Memo: M015-A

Ancoats Gardens, Rochdale Road, Manchester

Proposed acoustic testing schedule

Level 06

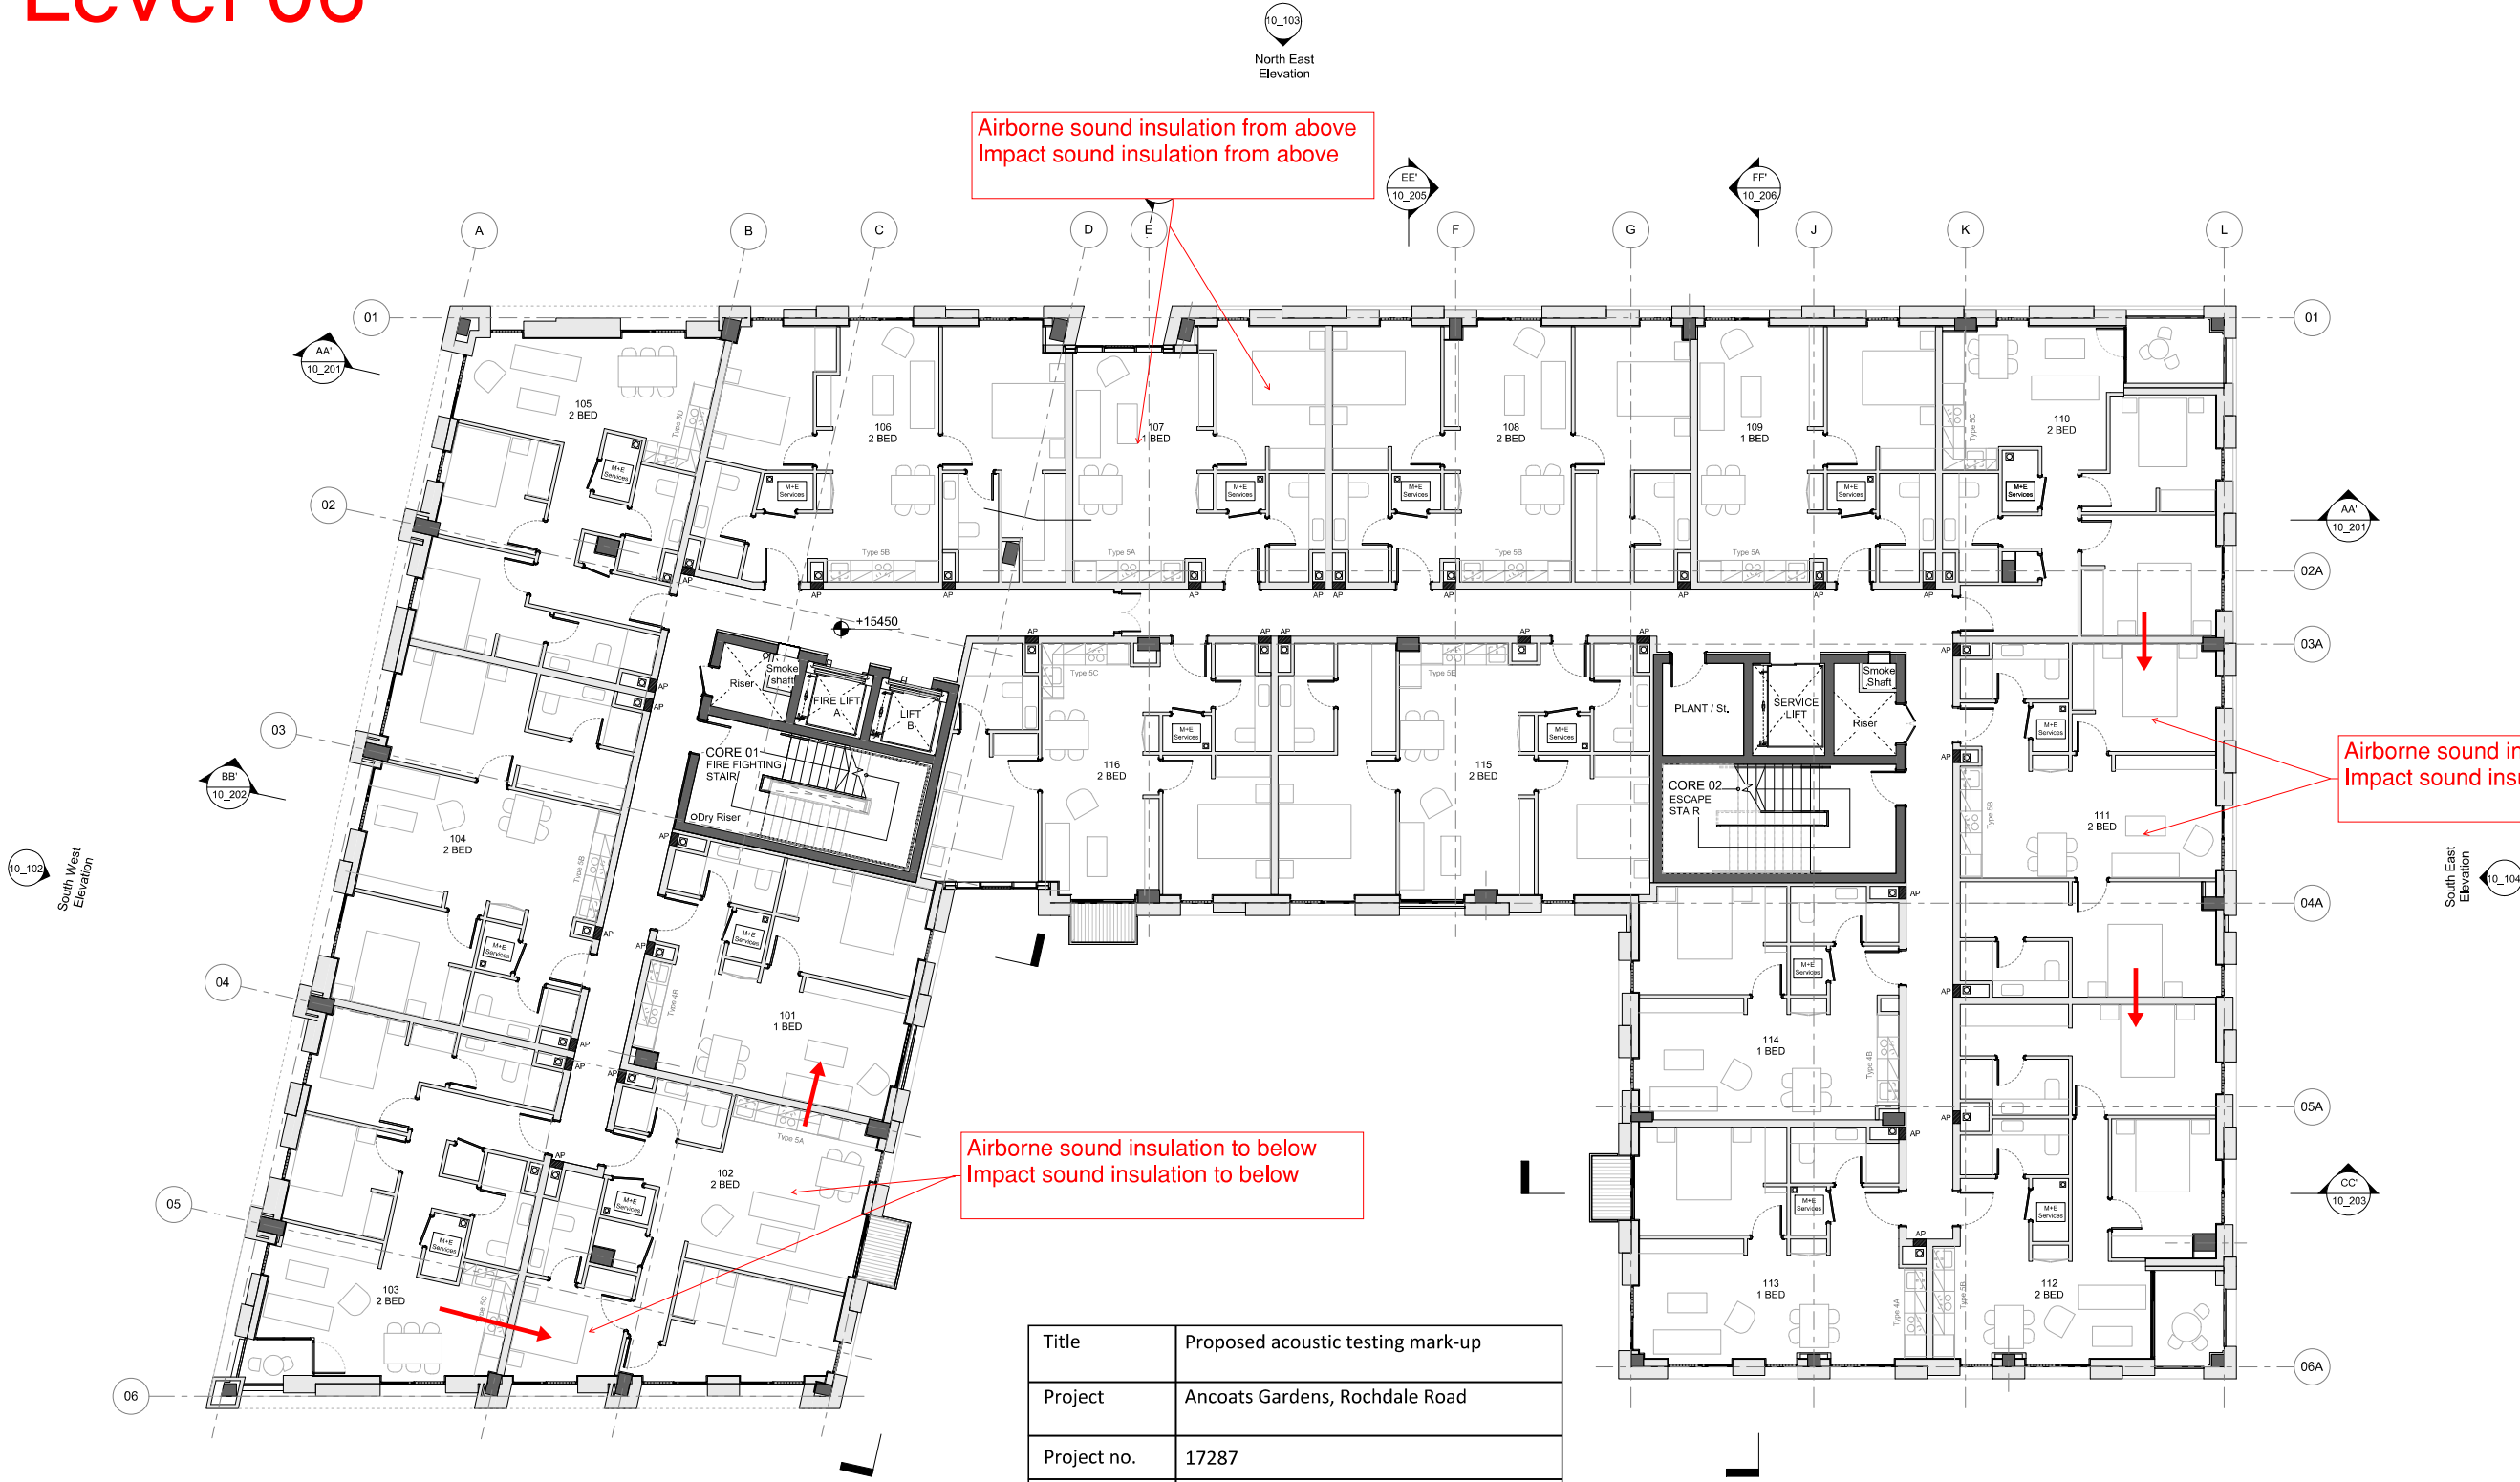
Airborne sound insulation from above
Impact sound insulation from above

Airborne sound insulation to below
Impact sound insulation to below

Airborne sound insulation to below
Impact sound insulation to below

Level 09

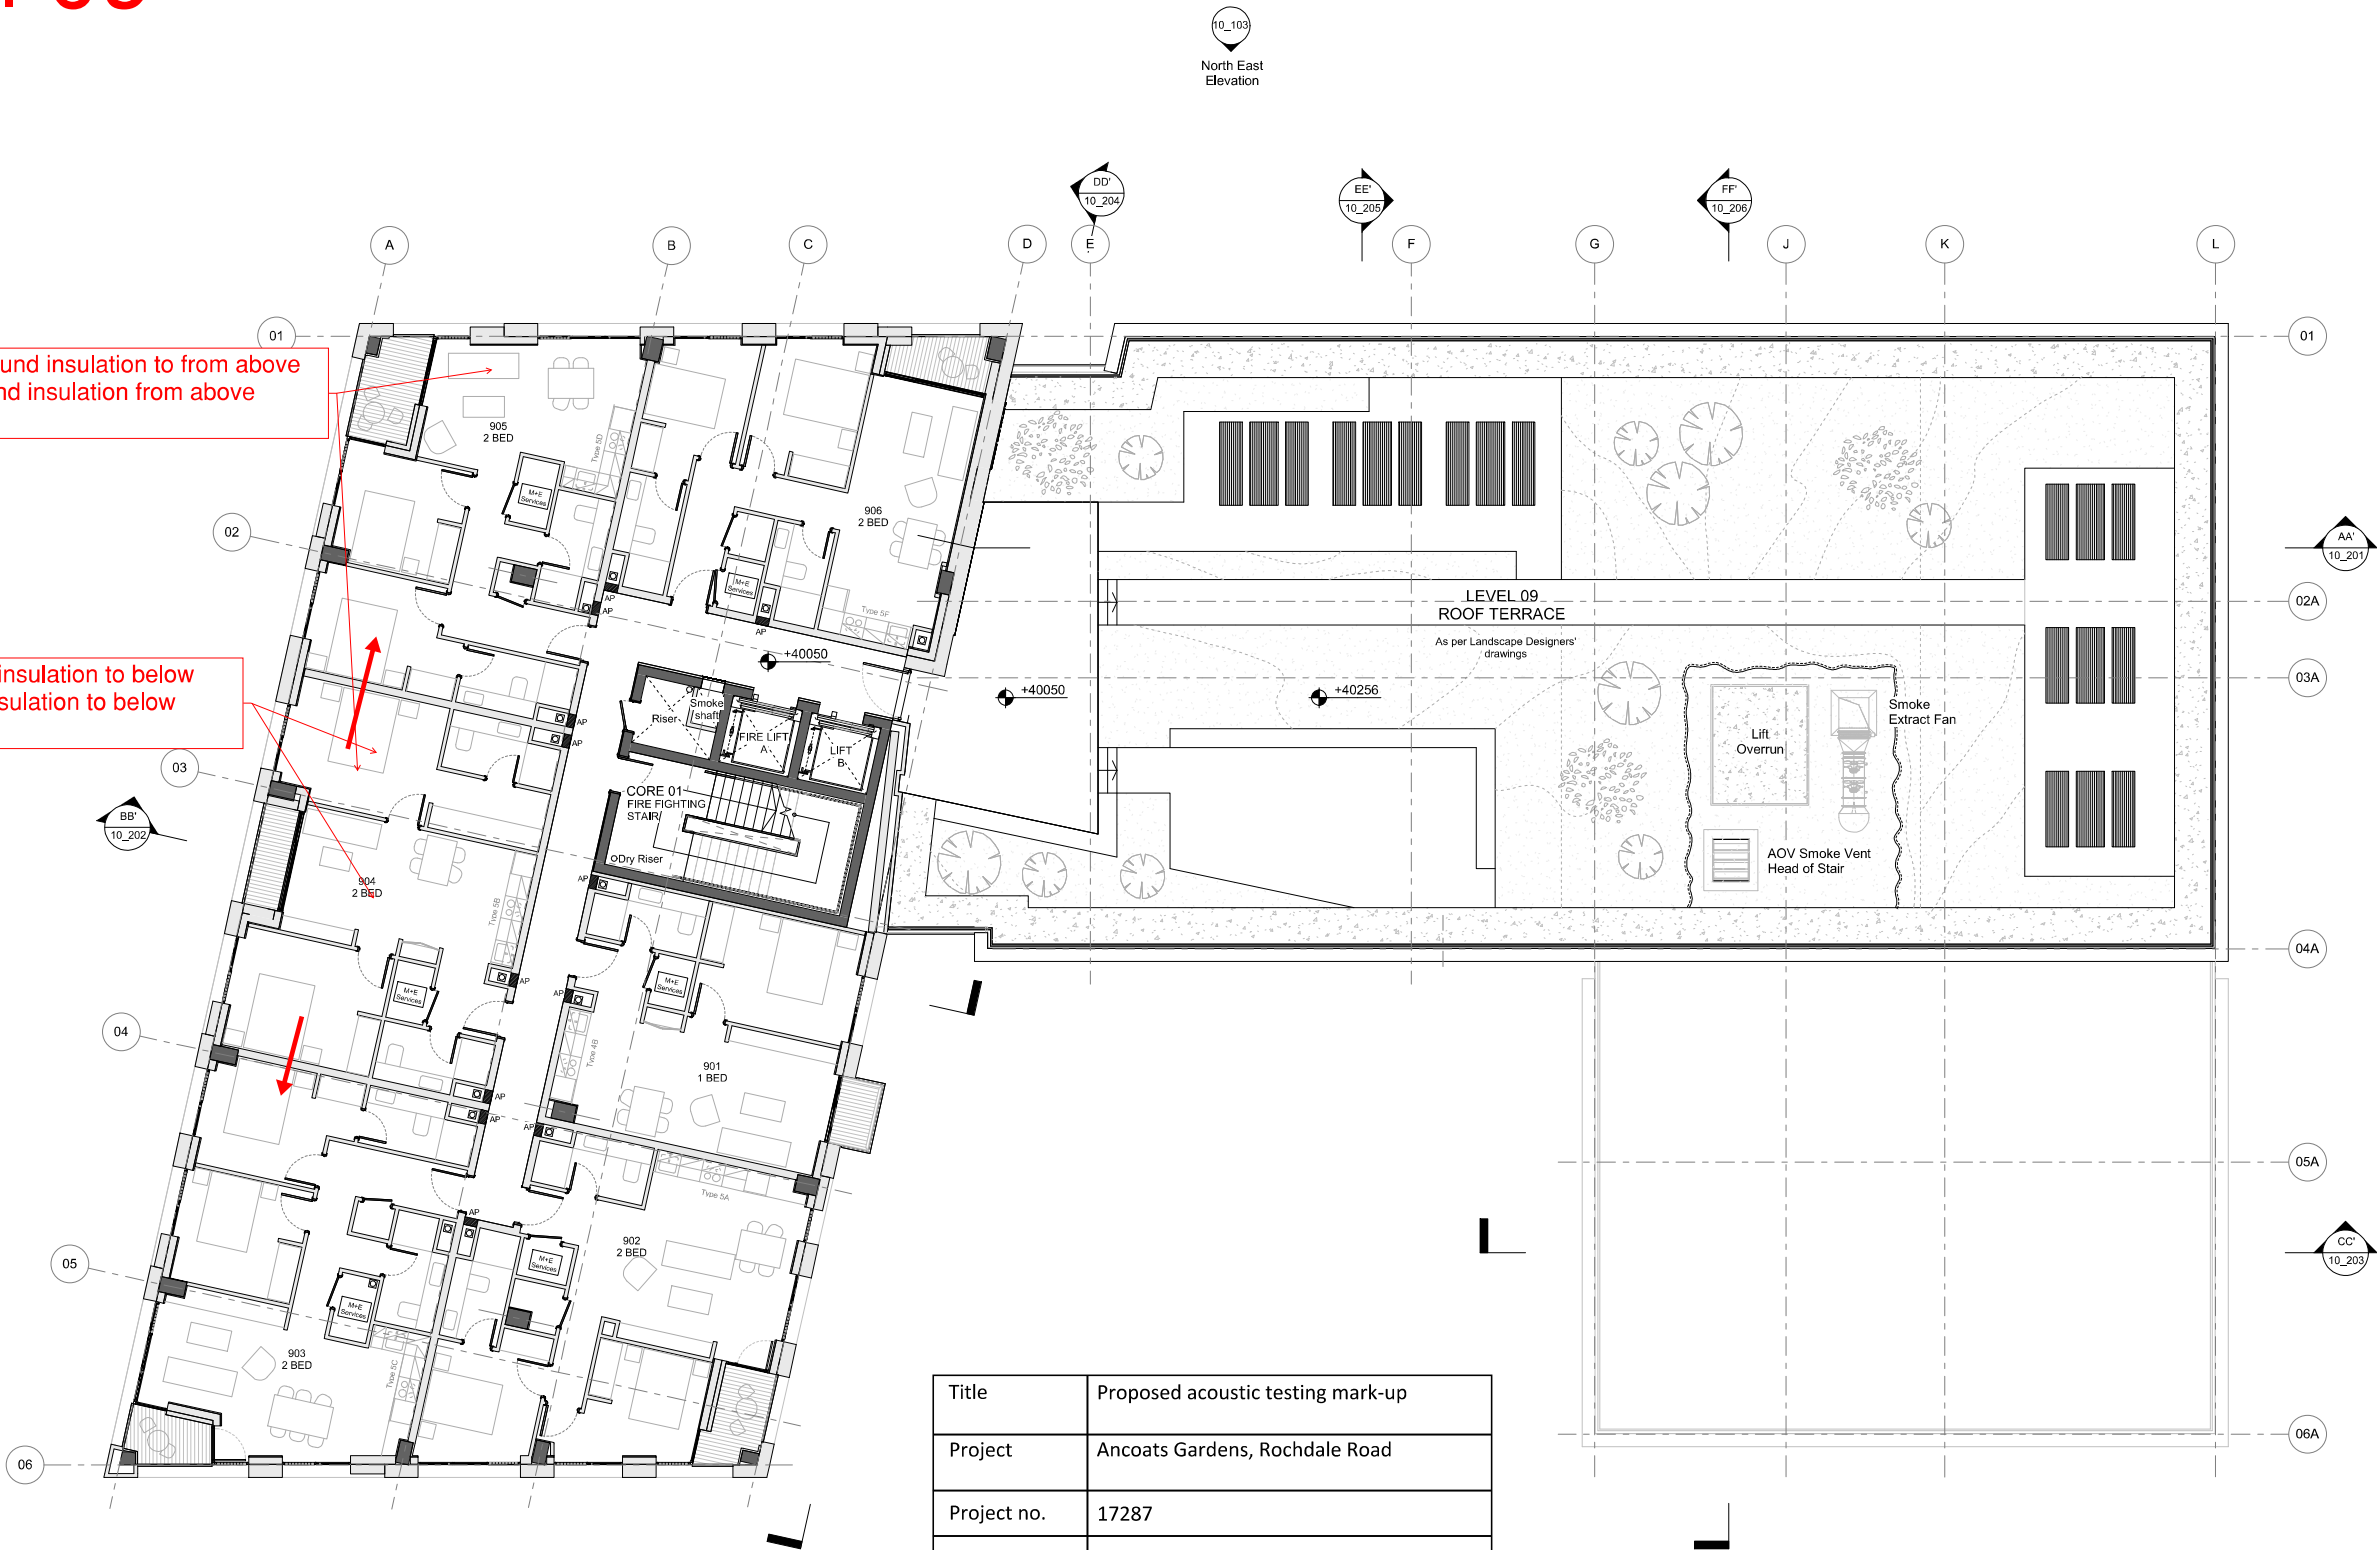
Airborne sound insulation to from above
Impact sound insulation from above

Airborne sound insulation to below
Impact sound insulation to below

Level 11

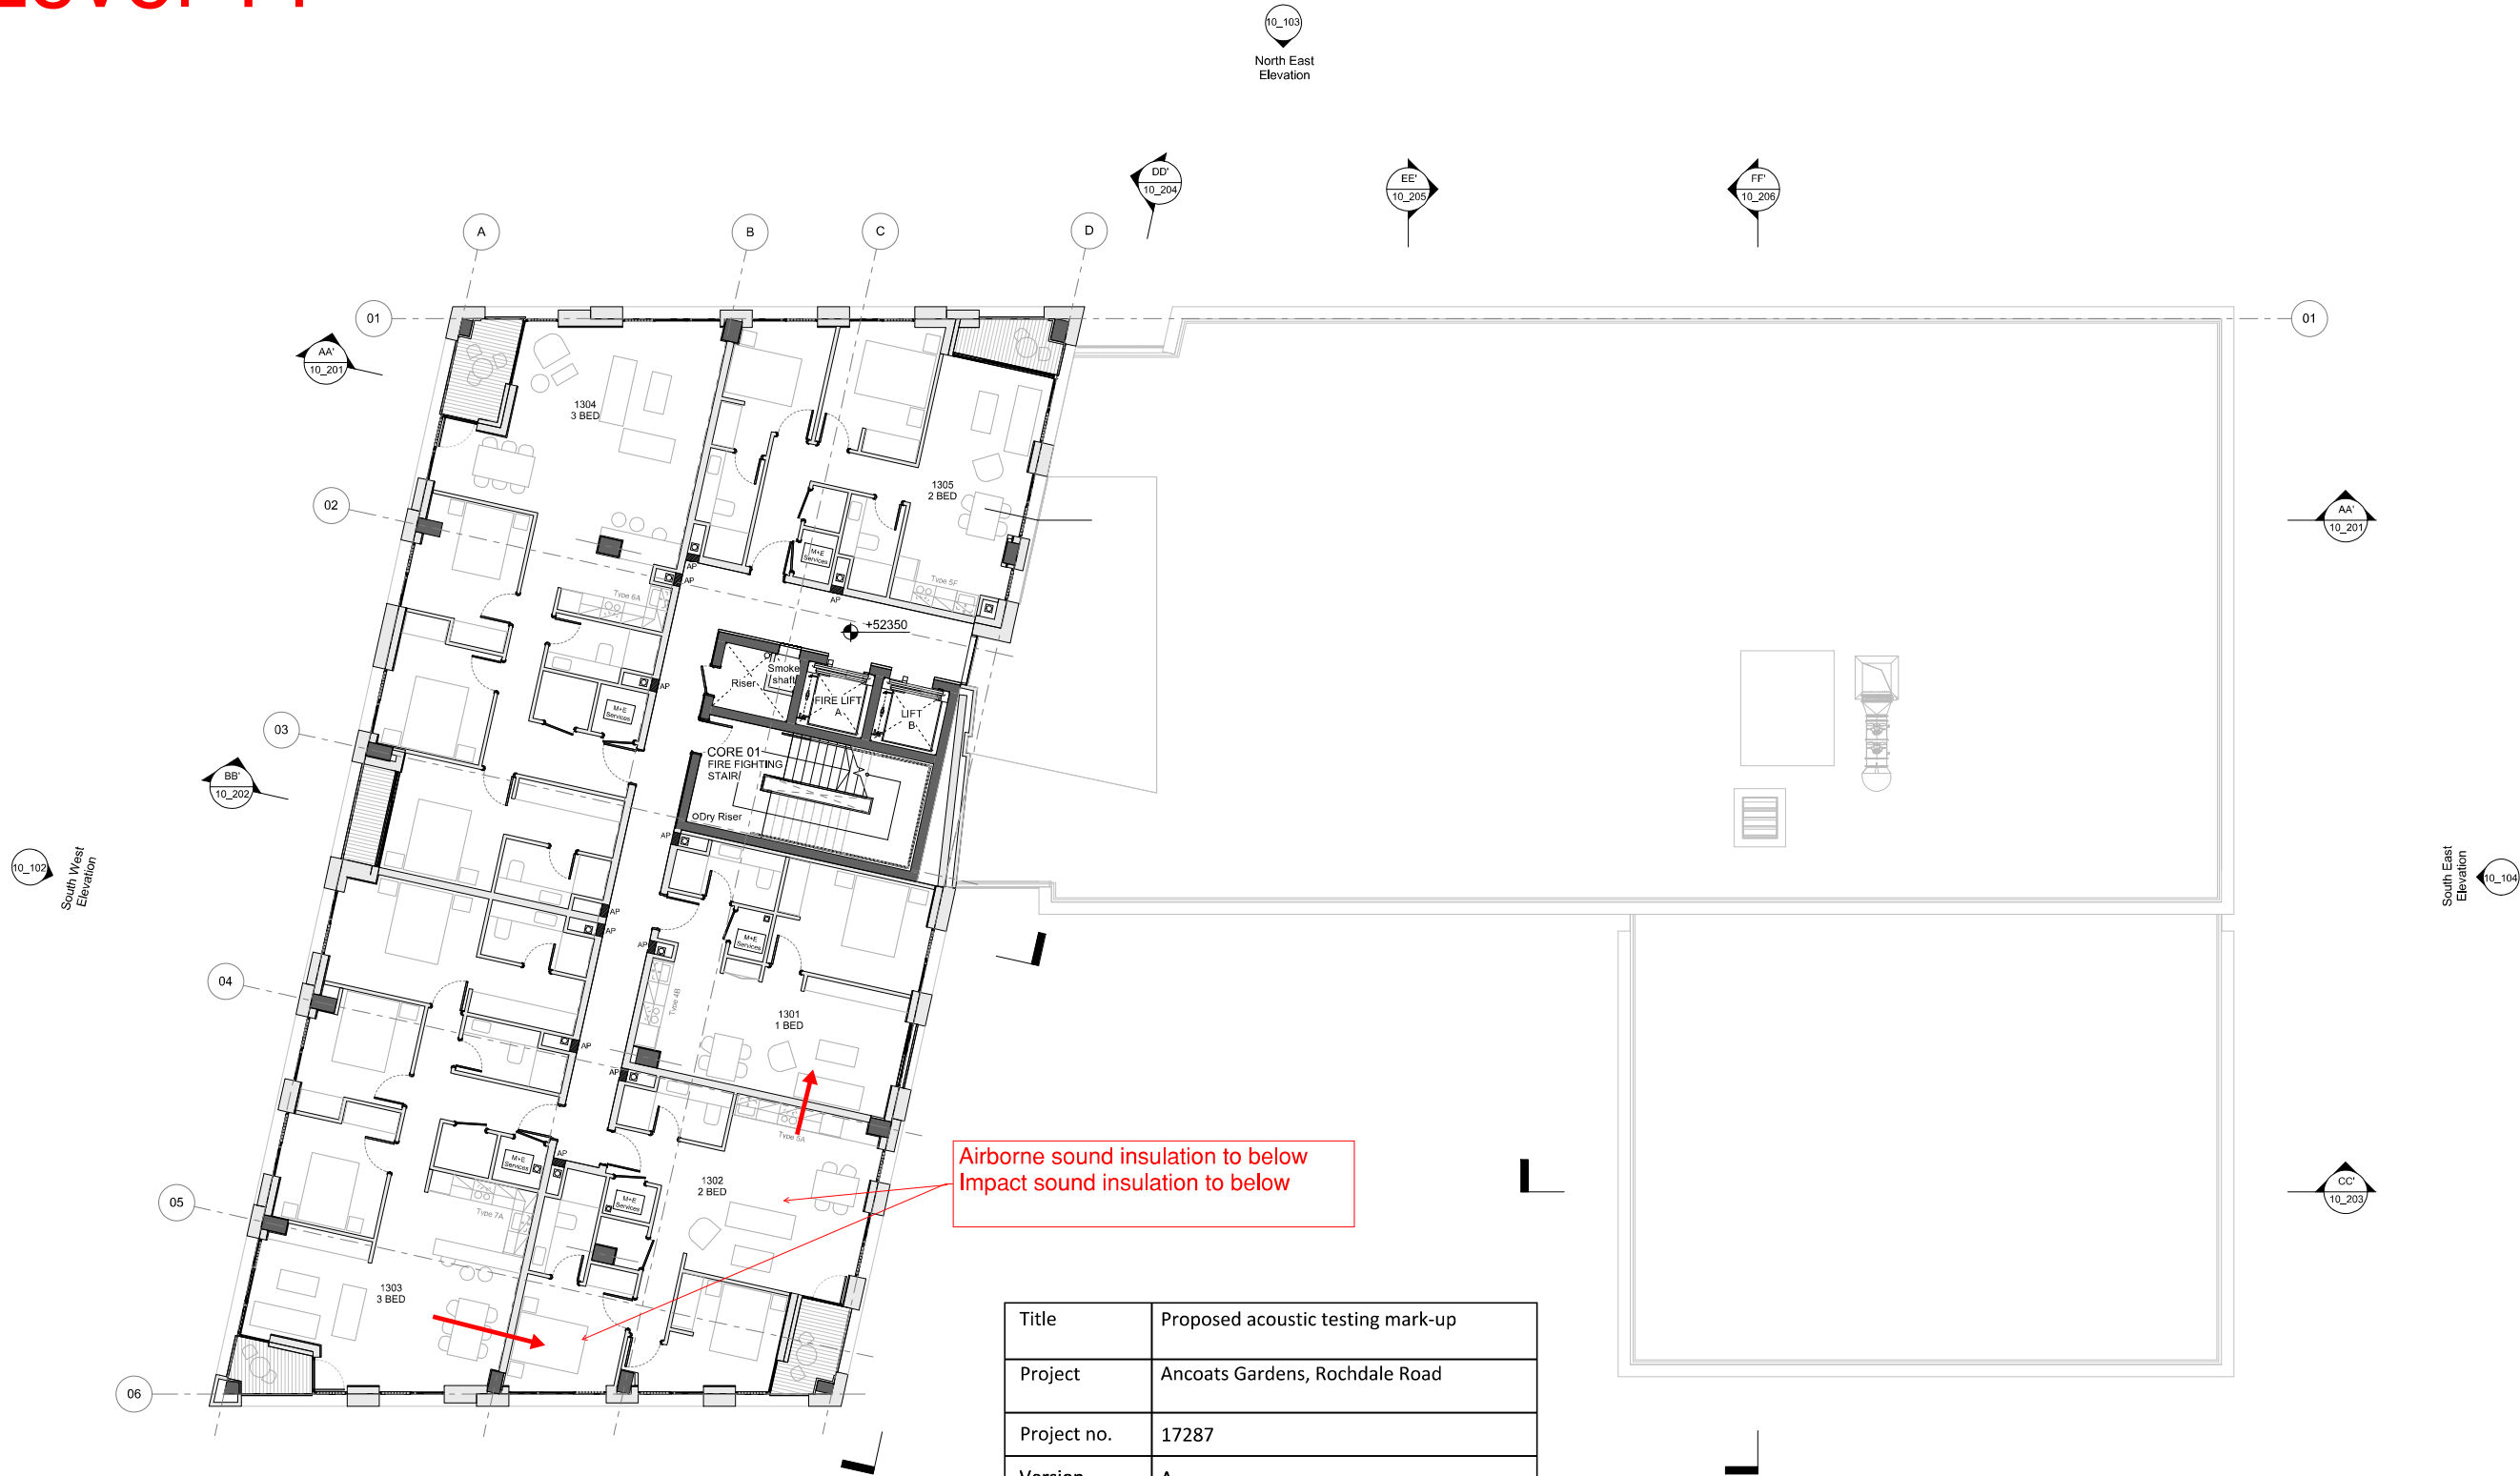
Airborne sound insulation to below
Impact sound insulation to below
